**Lindfield Learning Village**

Traffic and Transport Assessment -  
SEARs Comment Response

Issue | 20 November 2017

Scale at A3

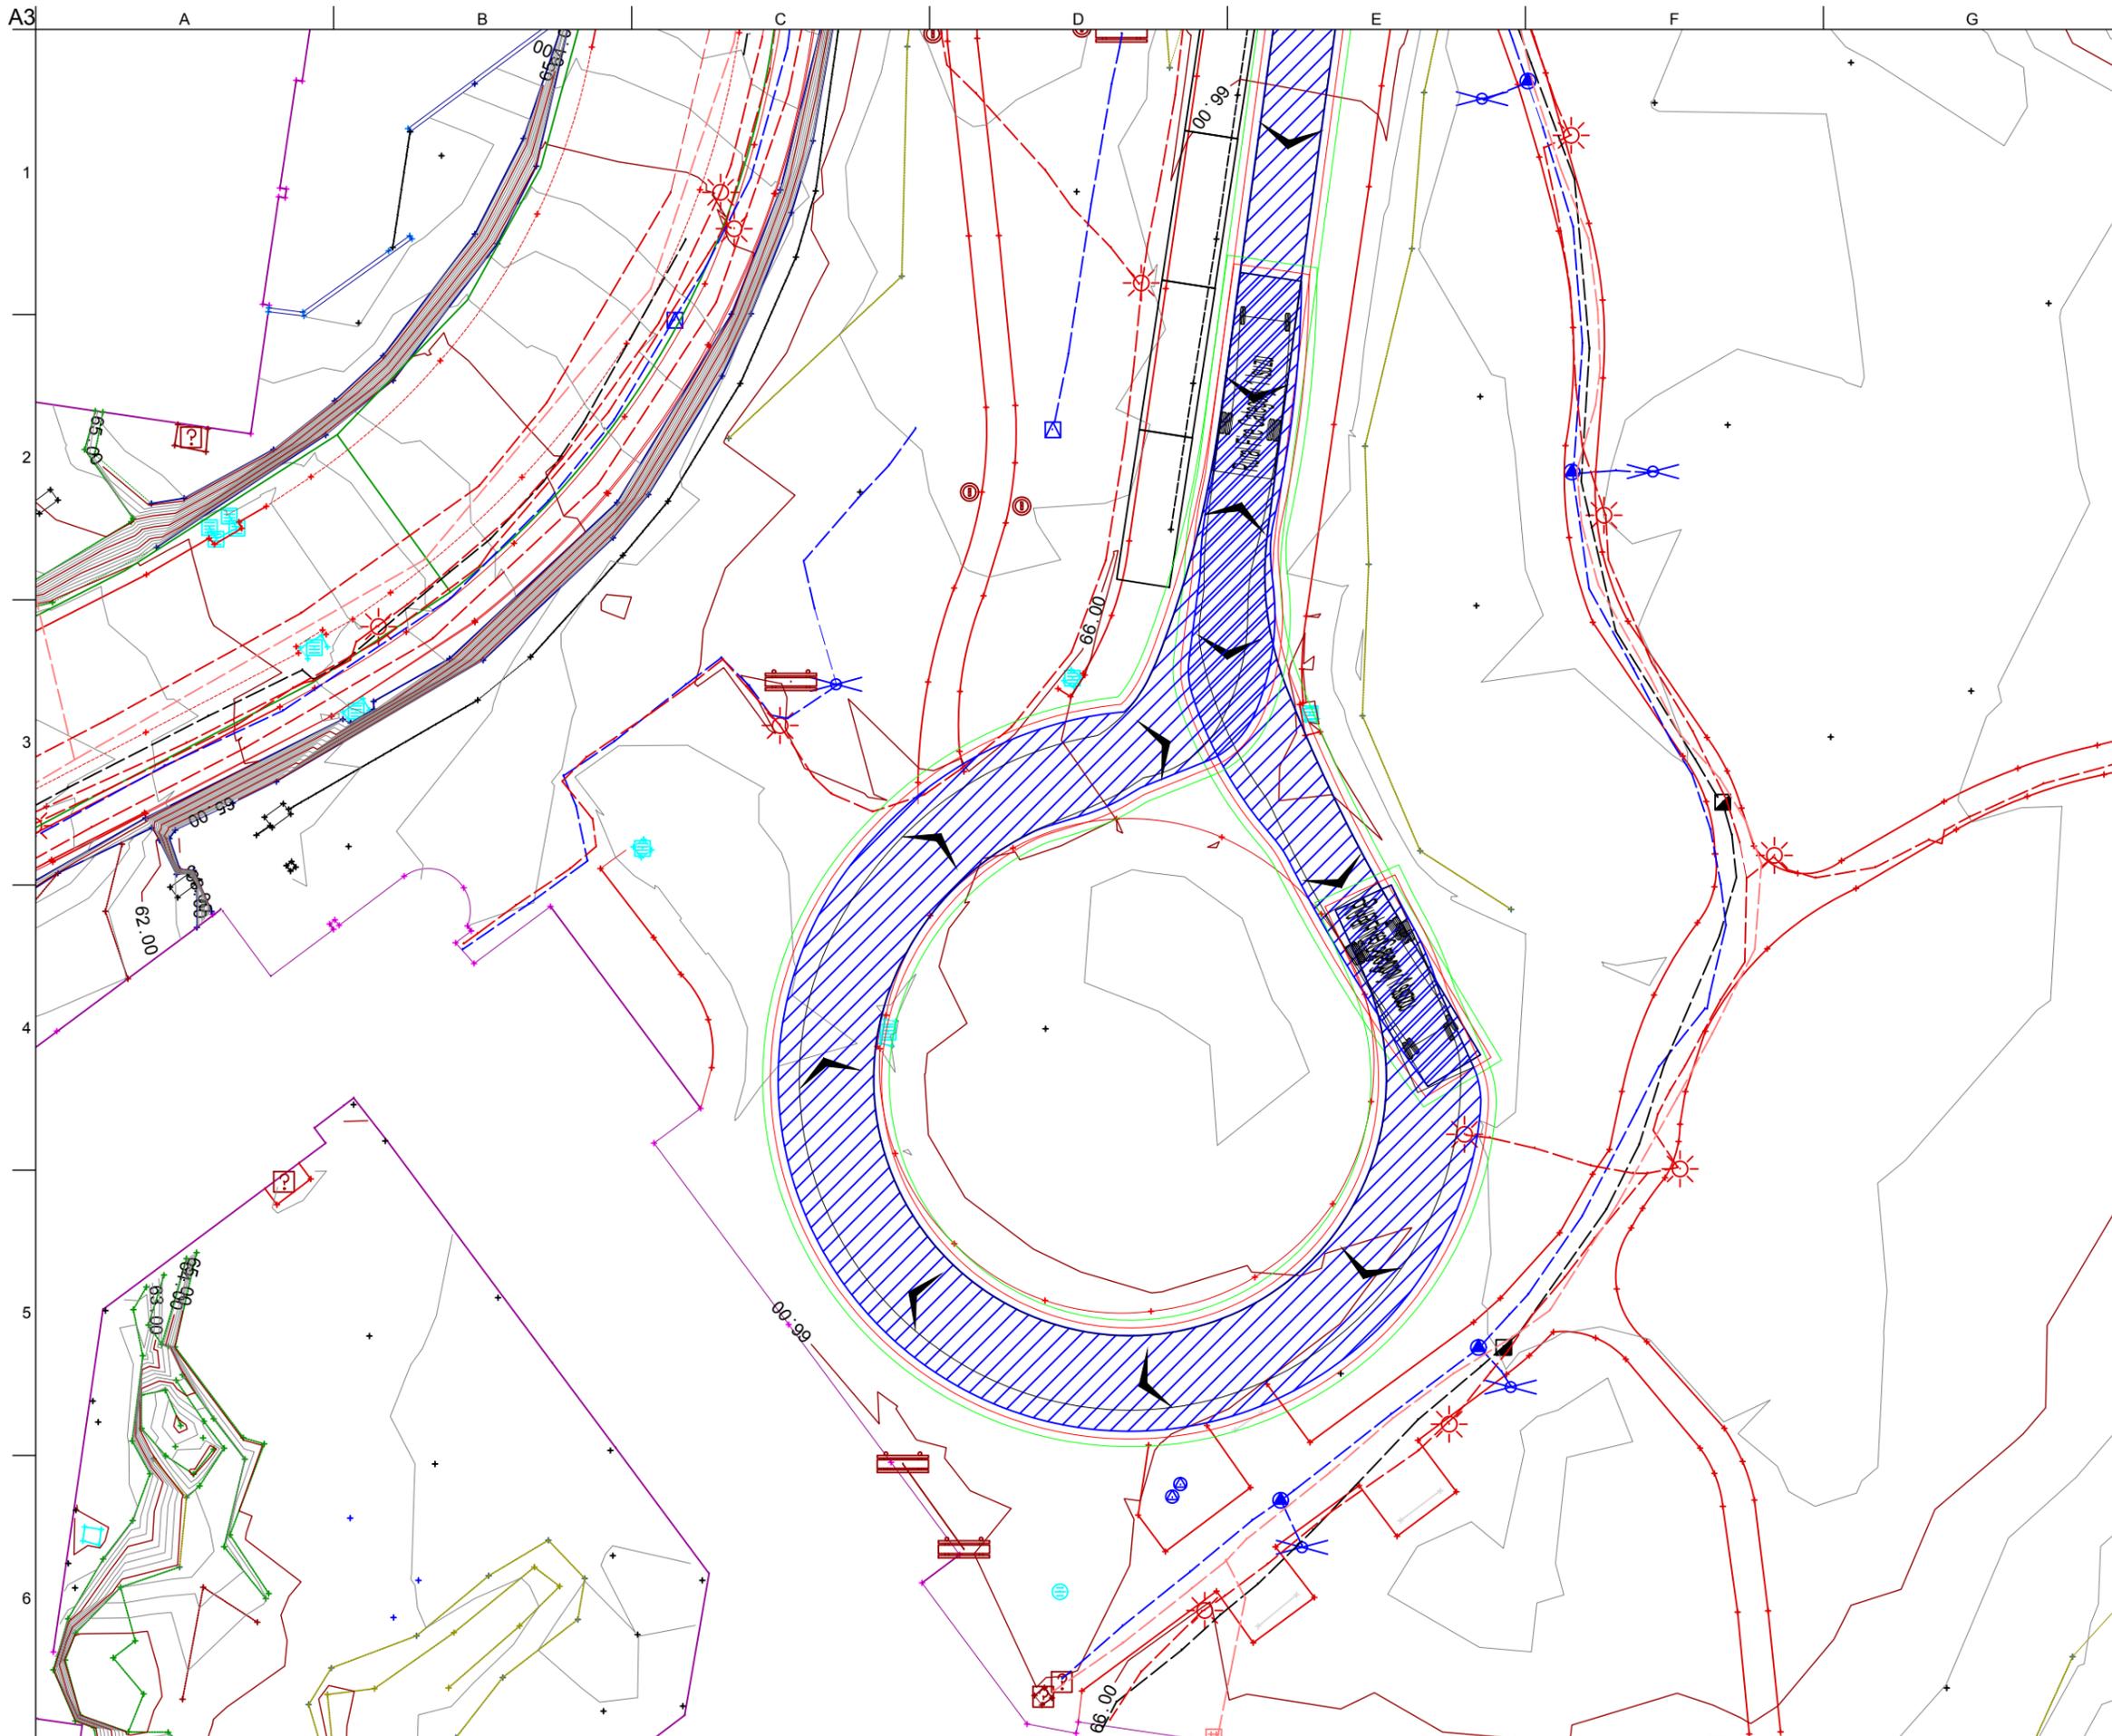
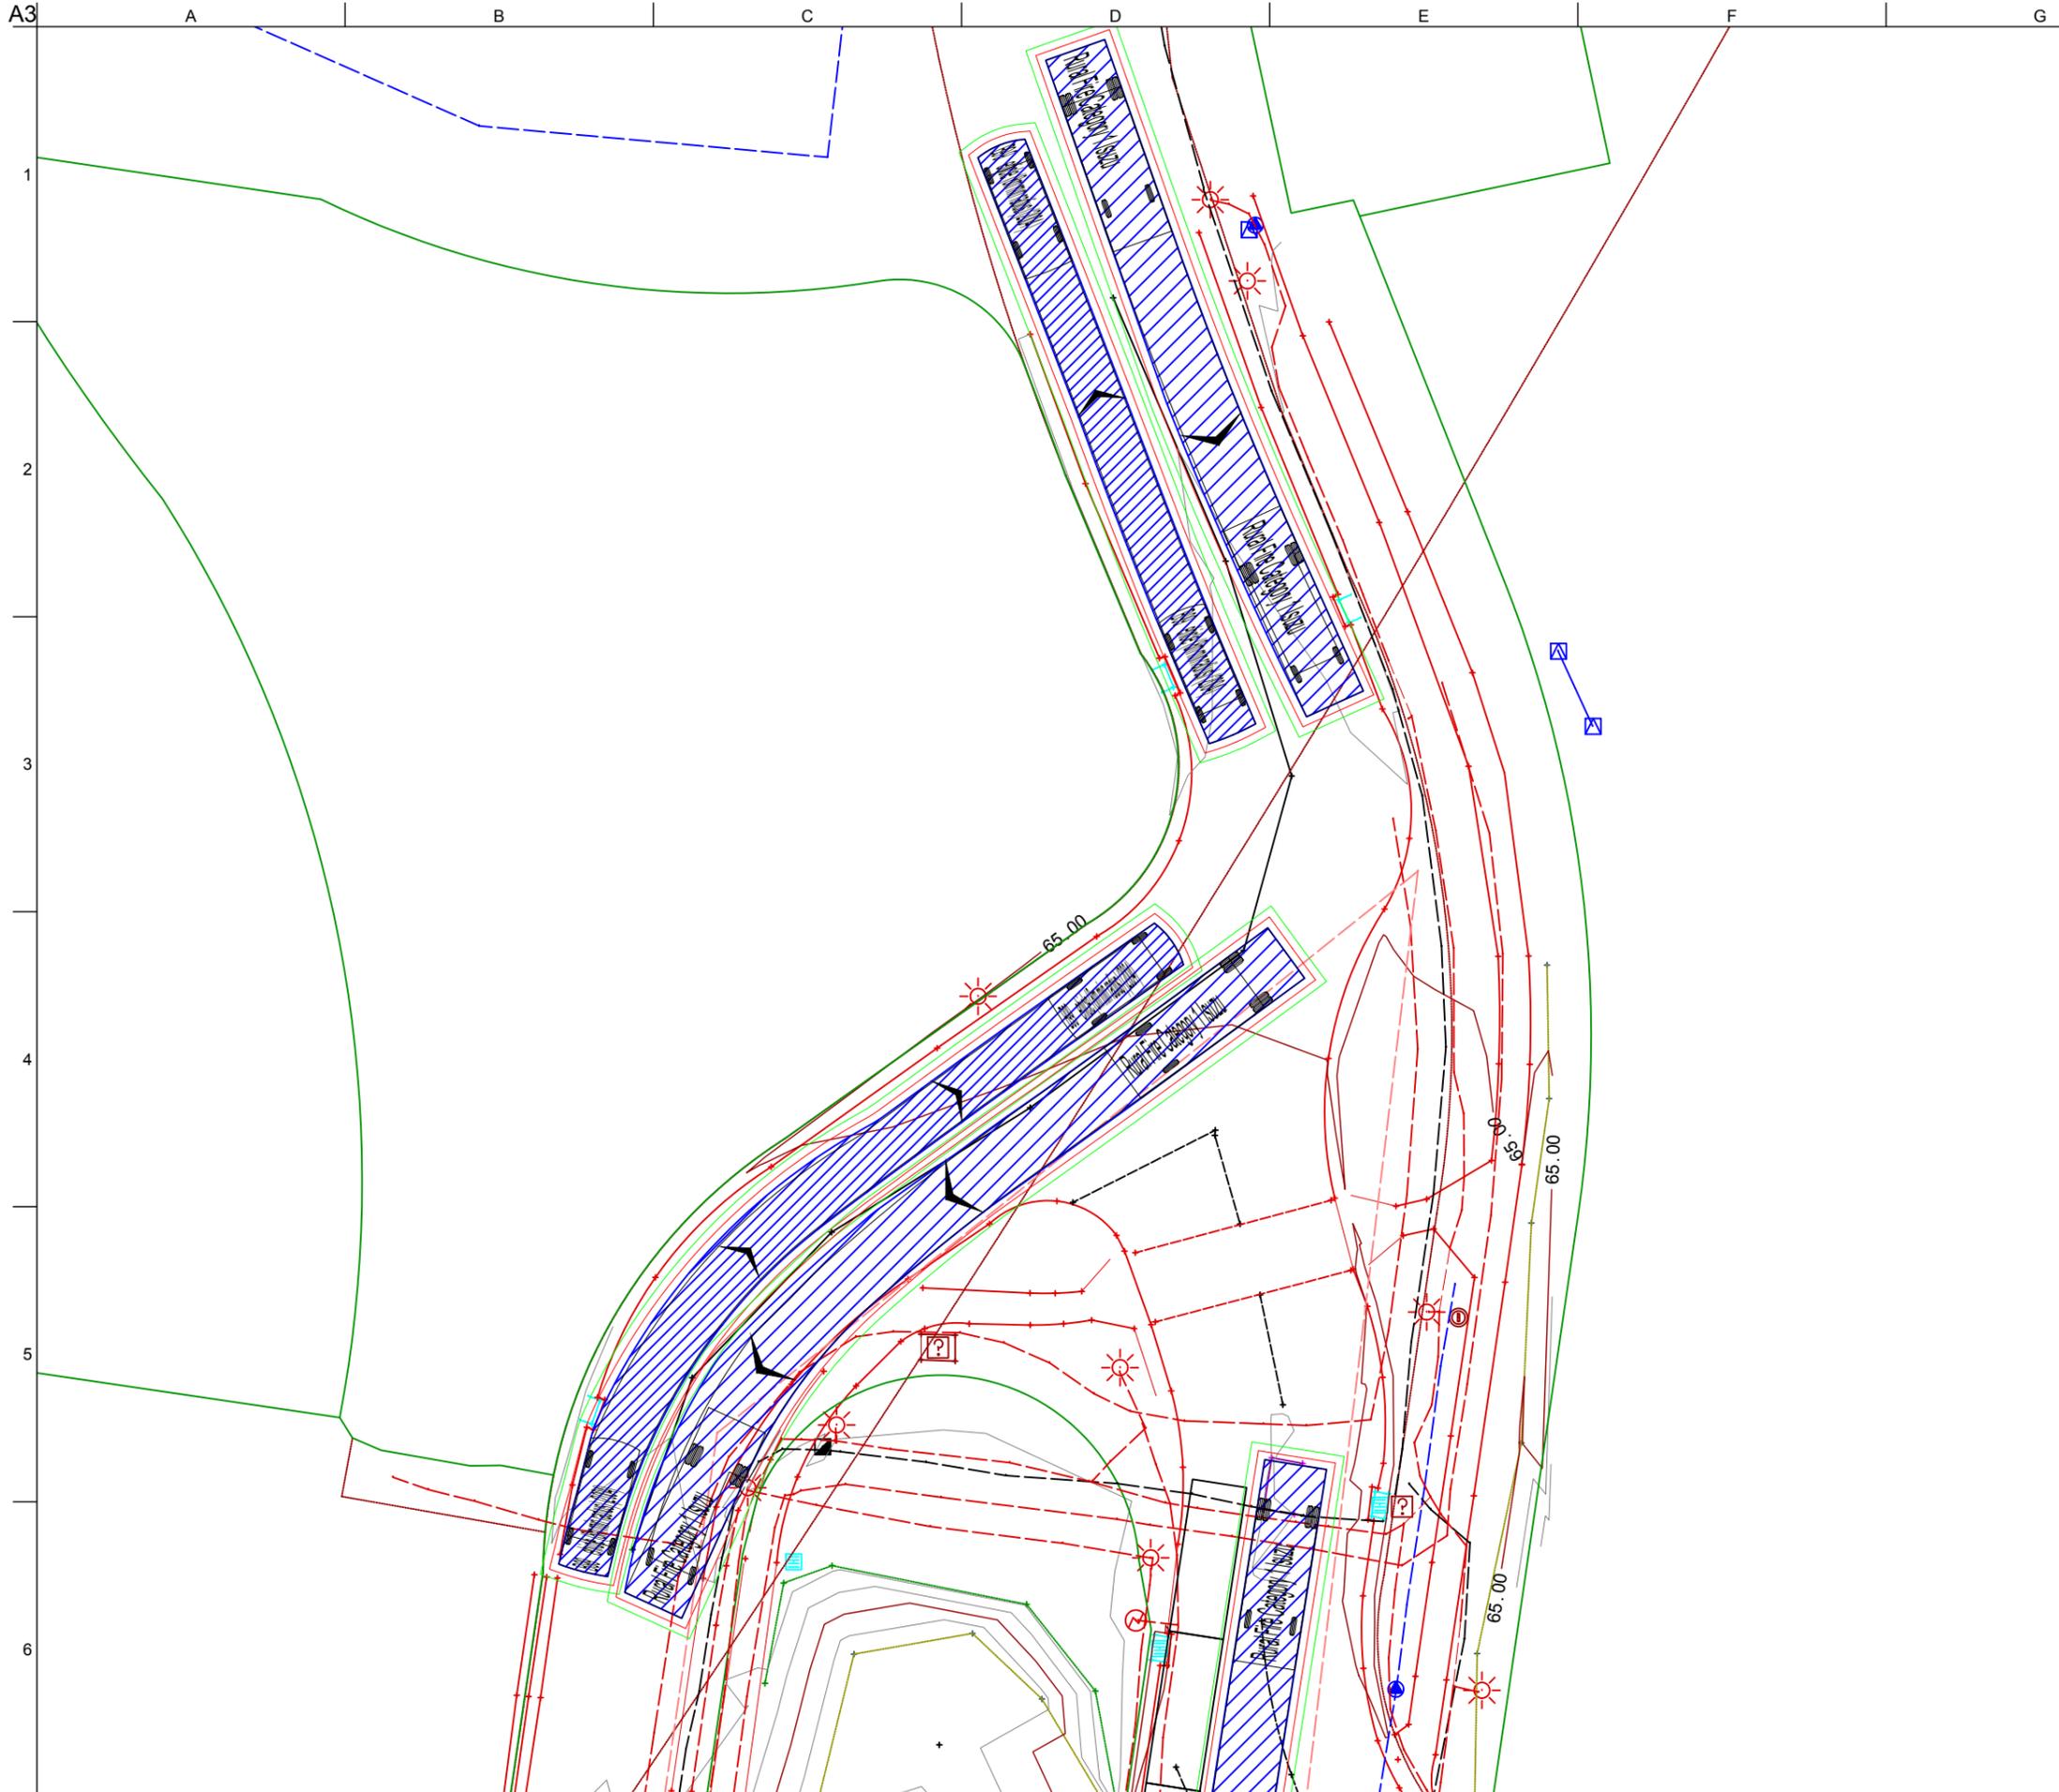
R#	Comment	Arup response
R1	[1] Given the narrow nature of the Eton Road access to the campus/school grounds, Roads and Maritime requires clarification regarding emergency vehicle access in emergencies.	Discussed in section 2.1
R2	[2] The existing bus bay/turnaround facility has inadequate holding capacity for the proposal as the proposed bus volumes will queue out onto Eton Road. Roads and Maritime does not consider the proposed bus bay appropriate for the following reasons:	The number of buses accessing the bus bay at any one time will be limited to its holding capacity.
R3	[2.1] The bus bay rank arrangement only allows for buses to arrive in a specific order to access their specific route rank. If buses arrive out of order, heavy delays will result from buses having to queue outside the bus bay. There are no opportunities available for buses to leap frog each other to get into the correct order before proceeding into the bus bay.	<p>Buses will not need to arrive in any specific order. The proposal shown in Section 2.2 allows enough pedestrian area for students to proceed to the correct bus when it arrives. Buses will be scheduled to arrive ahead of the pick-up time. Buses will therefore wait in order and depart at the same time.</p> <p>The proposed design looks at an arrangement where pedestrians walk on a 3m wide footpath around the bus bays This results widening of the bus roadway into the central void space to allow for bus turning.</p> <p>It was agreed that buses would not be able to leap frog past each other. The proposed arrangement would have buses waiting for children, negating the need for leap frogging. It was agreed that fencing would be provided for the safety of students as well as the possibility of a gate system at the pedestrian boarding locations. It was agreed that these access points need to be monitored and managed by traffic wardens / teachers.</p> <p>DPE advised that the bus bay could be dealt with as a condition of consent. The design requires formal approval from Council, TfNSW and RMS, and would need to include a detailed design and a detailed explanation of how students would board the buses. Safety is paramount.</p>

Emergency vehicle swept paths have been carried out for different areas of the site using MRV Fire Ladder 7.8 metre truck or a CAT 1 Tanker. The swept path analysis has indicated multiple opportunities for the truck to turnaround efficiently, shown in Appendix A.
